Re: Draft Environmental Report April 2019

Kilarc-Cow Creek Hydroelectric Project

License Surrender

South Cow Creek / Hooten Gulch Abbott Ditch Take-off Area
[a] Survey 10/02 -10/07 1911 Map [Recorded]
[b] Right of Way Deed E. Wagoner, etal . to W. Abbott 07/31/1912
[c] Right of Way Deed N. Wagoner to B. Abbott 06/24/1980

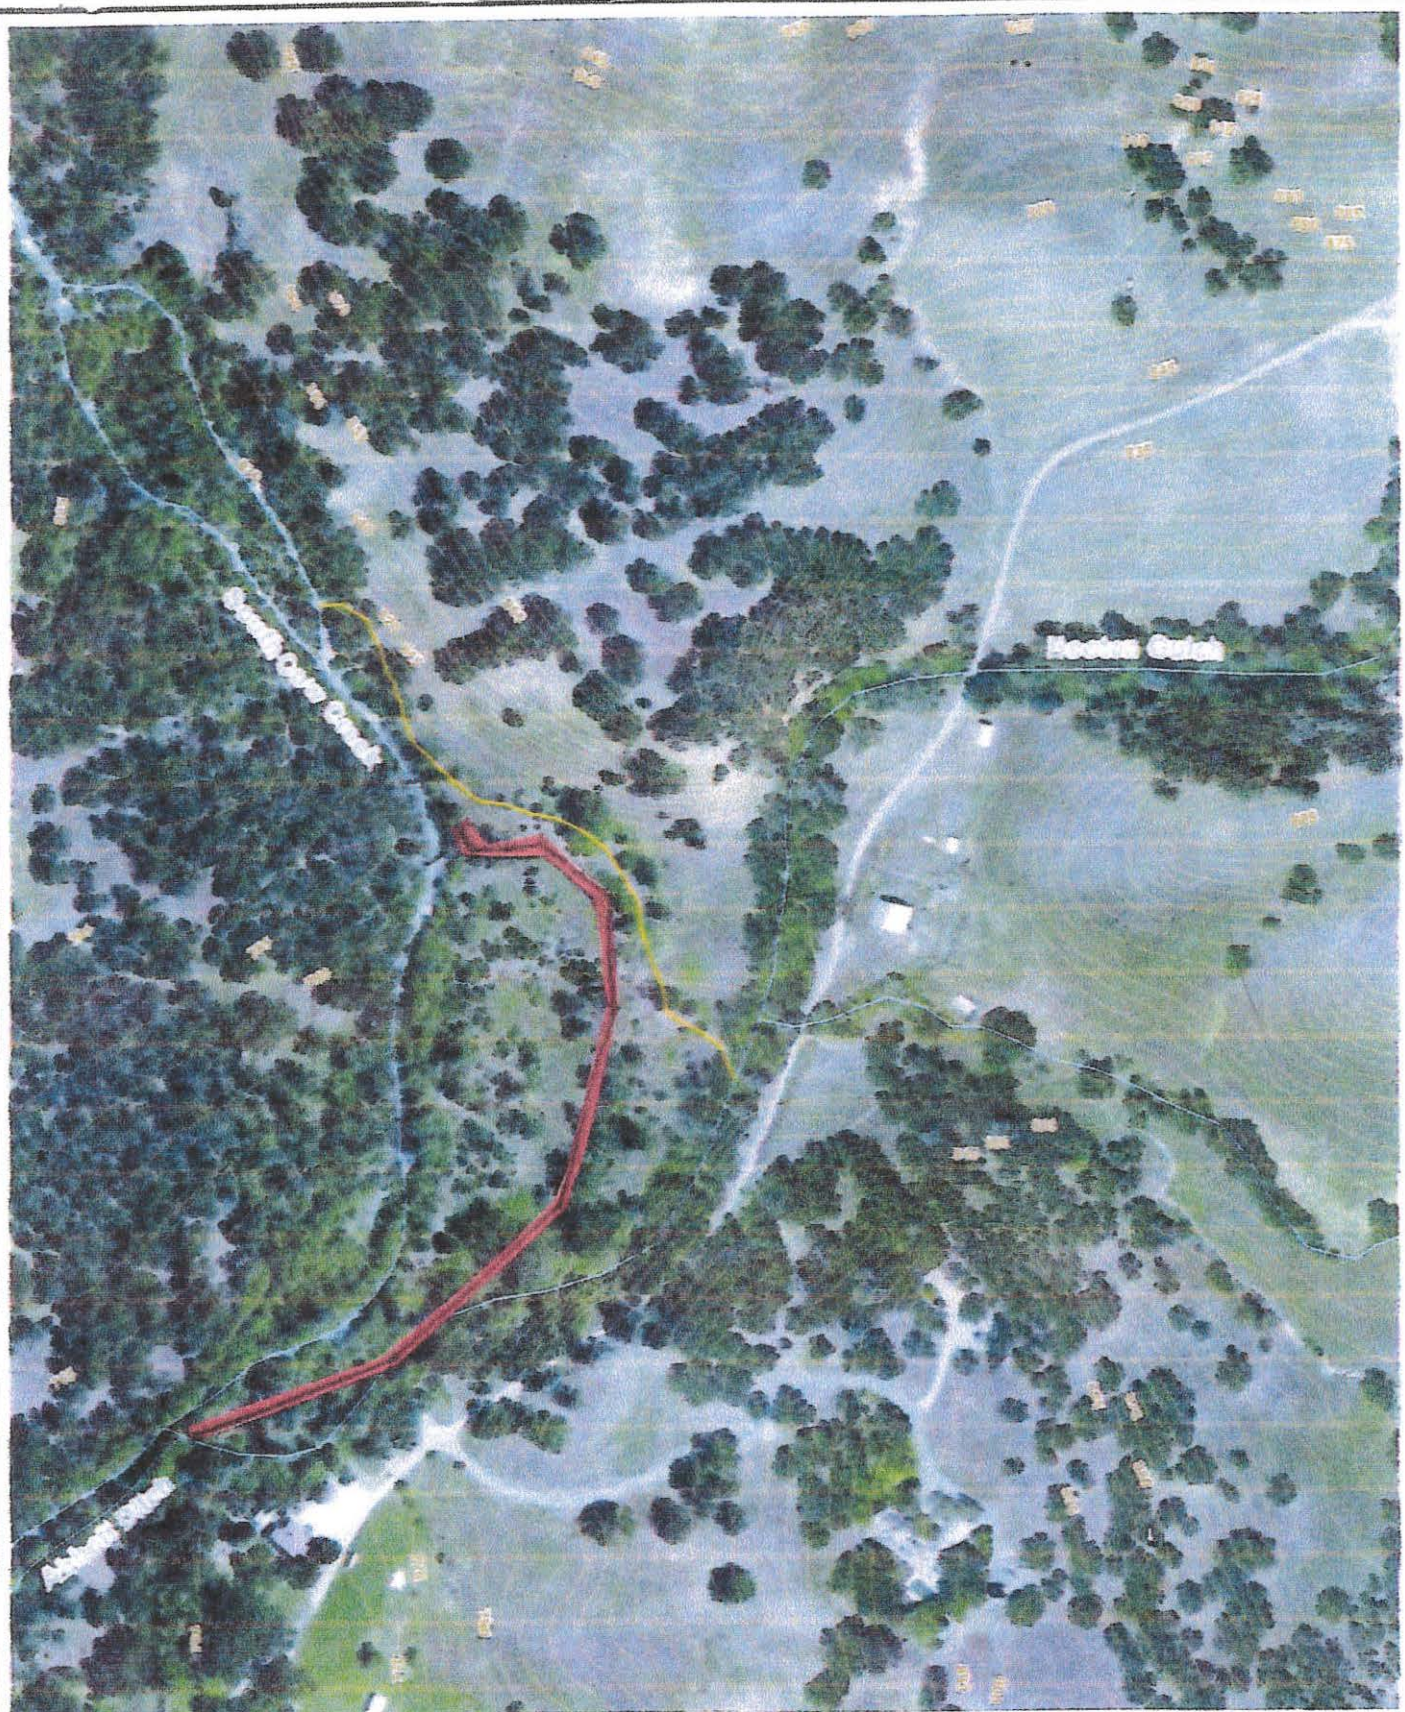
- b. It would be helpful to have a specific Figure or Map for the 3.3.2 area that incorporates all items associated with the various proposed [valid] alternatives. Map should incorporate items such upper end of boundary for ADU agricultural area; labels on East Channel / West Channel of south Cow Creek; Div. 72 location on East channel; existing Div. 73 structure in Hooten Gulch; 1911/12 Right of Way water course path from South Cow to Div. 73; Option B course; Option C location, Option D course. See Attachment "A" map that has some of the above. This attachment reflects that South Cow Creek channel has shifted about 50 feet to the West of where it was in 1911 with respect to ADU water rights diversion structure; and that Hooten Gulch has also had shifts in course towards the East.

ATTACHMENT B

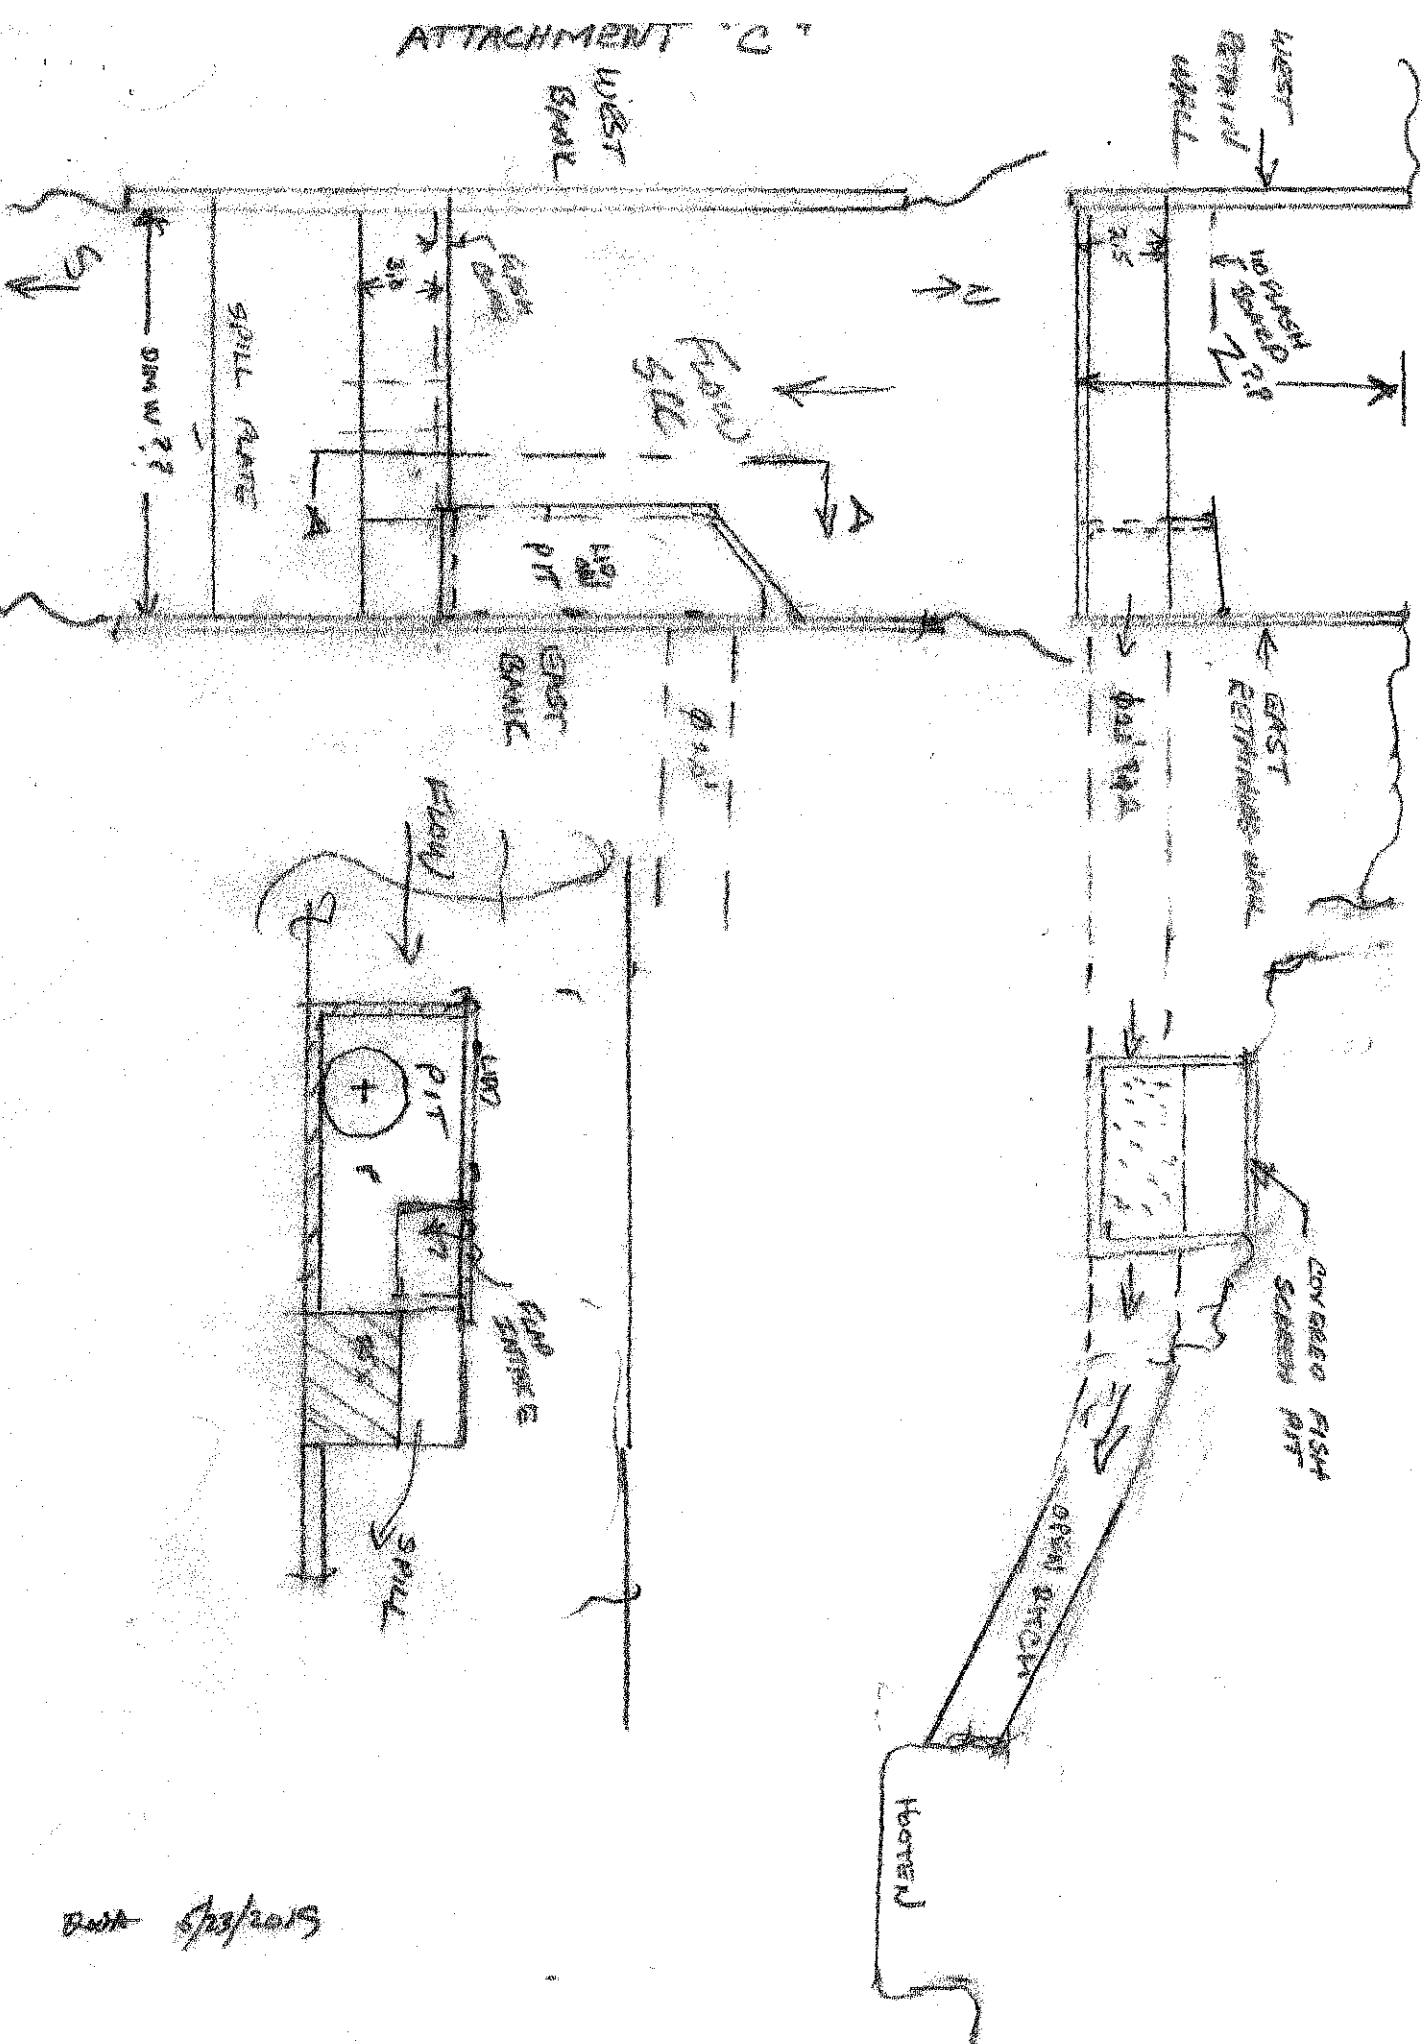
- d. It could be helpful if the adjective "East" was deleted in 3.3.2.2 text (2x places).
 - e. See Attachment "B" with how "East Channel" adjective in used for description of Diversion 72 in the 1965 Water Rights Report.
